Title: Inspection of Rotor head		
AG-SB-2022-09-B-ENR2	Effective Date: 07.10.2022	Compliance Category:
Applicability		A - MANDATORY B - RECOMMENDED C - OPTIONAL
Aircraft type & model: All Cavalon and Calidus with Rotor head III	Affected Serial number(s): All Cavalon and Calidus with Rotor head III	
The maintenance manual to be referenced is this stated or subsequent issue.		As per AutoGyro website
<p>This form is the response from AutoGyro GmbH either against a problem found in the product in service requiring a containment or rectification action, or as service information for aircraft modification incorporation. For help, contact airworthiness@auto-gyro.com.</p>

Reason and overview of the Service Bulletin (cause of problem if known)

Rotorhead III

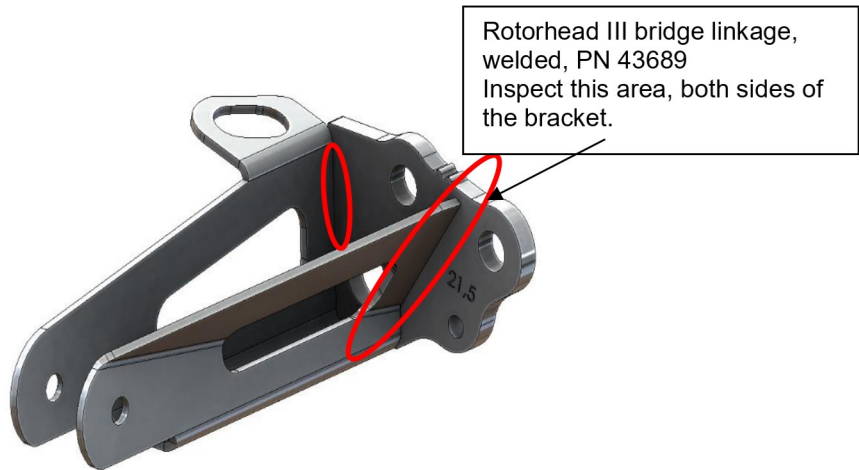
Pre-flight inspection requires a thorough review of the rotorhead. Pilot/operators are reminded that this includes the welded connection between the side plates and roll link bracket shown below. This area is open for easy inspection.

The ringed area indicates the installed bridge linkage

External weld with crack:
This area is readily inspected during pre-flight inspection

If a crack is found, the part is to be replaced in accordance with normal maintenance procedures.

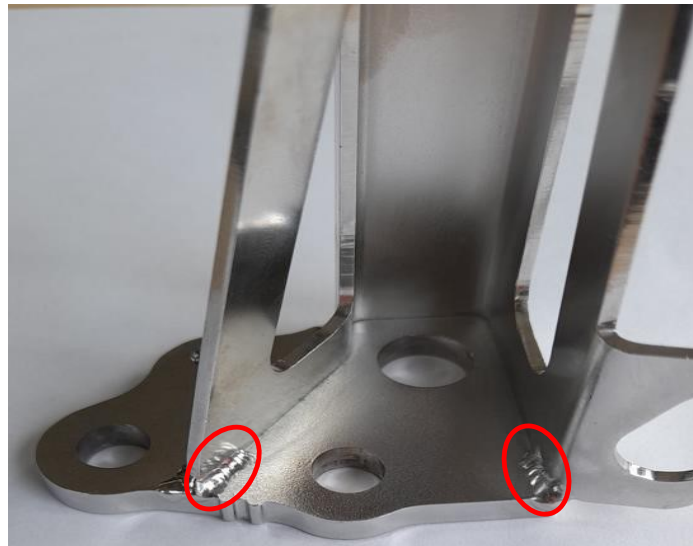
There are two generations of the Rotorhead III Rotor head bridge roll linkage assemblies. The second generation is welded on the inside upper end of the bracket, see photo, and was released in 2019. Only this later generation is available, and is fully interchangeable with the earlier version.

Note: these assemblies are stamped with the size (21.5 and 22.5). If replacing, ensure that the correct size is fitted!
